MONTGOMERY COUNTY HISTORIC PRESERVATION COMMISSION

STAFF REPORT

Address:	17715 Meeting House Rd., Sandy Spring	**Meeting Date:**	6/8/2022
Resource:	Contributing Resource **Sandy Spring Historic District**	**Report Date:**	6/1/2022
Applicant:	Sandy Spring Monthly Meeting Miche Booze, Architect	**Public Notice:**	5/25/2022
Review:	HAWP	**Tax Credit:**	n/a
Case No.:	991955	**Staff:**	Dan Bruechert
Proposal:	Kiosk Installation

1 SITE PLAN
N.T.S.

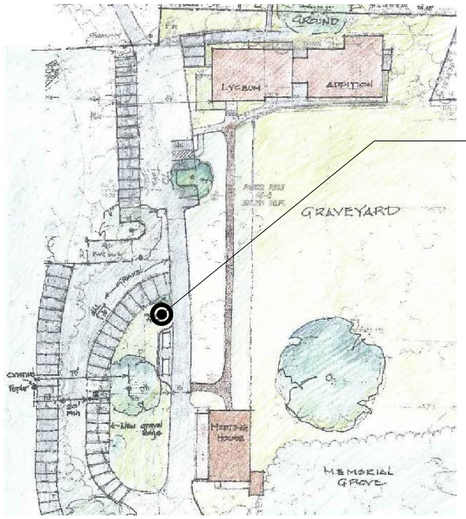
The applicant proposes to construct a small L-shaped information kiosk near the northwest corner of the property. The kiok will be constructed out of wood posts and dimensional lumber with a metal roof. Staff finds it will not obscure the views of the historic meeting house from the road and will not be placed in a location that would diminish or obscure any character defining features of the district.
